## Bright Future Africa- Vol.2 (Uganda)

### Validation Report

Title of report	Bright Future Africa - Vol.2 (Uganda)
ID of report	CC IPL1949/ICR/VAL/GROB/20230710
Client (Project proponent)	GRO Foundation
Criteria for validation	<input type="checkbox"/> ICR requirement document v.4 <input checked="" type="checkbox"/> ICR requirement document v.5 <input checked="" type="checkbox"/> ICR definitions version 2.0 <input checked="" type="checkbox"/> ICR process requirements version 5.0 <input checked="" type="checkbox"/> ICR Validation and Verification Specifications v1.0 <input checked="" type="checkbox"/> ISO 14064-2 <input checked="" type="checkbox"/> ISO 14064-3 <input checked="" type="checkbox"/> ISO 14065 <input checked="" type="checkbox"/> ISO 31000: NPR analysis tool applied for proposed project activity. <input checked="" type="checkbox"/> Applied methodology, CDM Methodology AR-ACM0003: Afforestation and reforestation of lands except wetlands - v2.0 <sup>1</sup> <input checked="" type="checkbox"/> CDM AR-Tool 02: Combined tool to identify the baseline scenario and demonstrate additionality in A/R CDM project activities v1.0

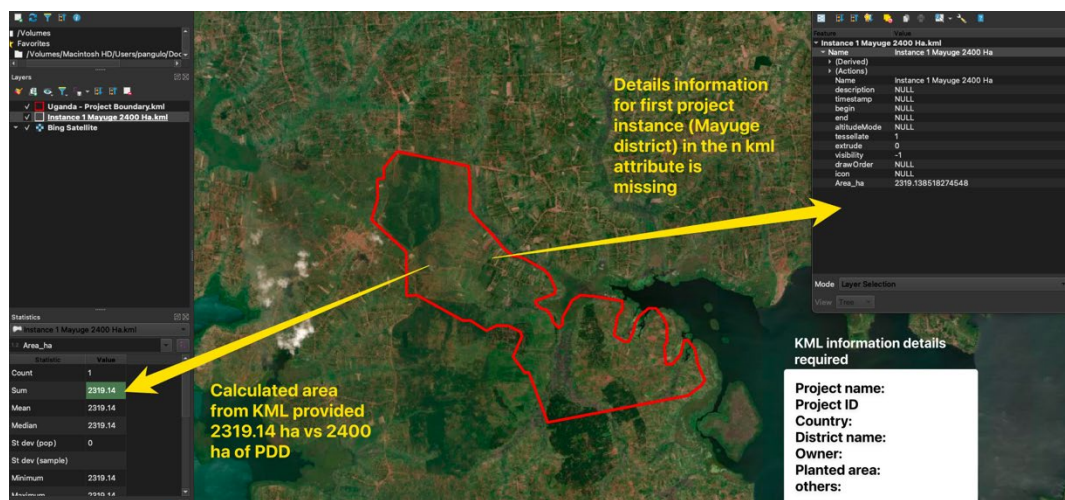
<b>CAR</b>	12	<b>Section no.</b>	<b>Date: 24/09/2023</b>
<b>Description of CAR</b>			
As per section 4.2 of the ICR requirement v4.0, PP shall provide the following maps and shapefiles			
<ol style="list-style-type: none"> <li>i) Project area with coordinates</li> <li>ii) Planting area with coordinates</li> <li>iii) Location of project boundaries</li> <li>iv) Map and shapefiles to delineate project boundaries.</li> <li>v) Grouped project Area</li> <li>vi) 1<sup>st</sup> Project activity project area</li> </ol>			
<b>Project participant response</b>			<b>Date: 12/10/2023</b>
KML files are provided : <a href="https://grofoundation.io/mapEarth.php">https://grofoundation.io/mapEarth.php</a>			
<b>Documentation provided by project participant</b>			
<i>KML file of 1<sup>st</sup> project activity area</i>			
<b>VVB assessment</b>			<b>Date: 07/02/2024</b>
<p>Through analysis of the files available at the link (<a href="https://grofoundation.io/mapEarth.php">https://grofoundation.io/mapEarth.php</a>) shared by PP, VVB found that the KML files provided are not in compliance of section 4.2 of of ICR PDD. PP is requested to provide separate downloadable shapefiles mentioned in the description above in .kml or shp format and not as a webmap link, where the shapefiles must contain the detailed information required in concordance with section 4.2 of ICR requirements.</p>

Downloadable KML files available in “CAR 06” folder of the Database
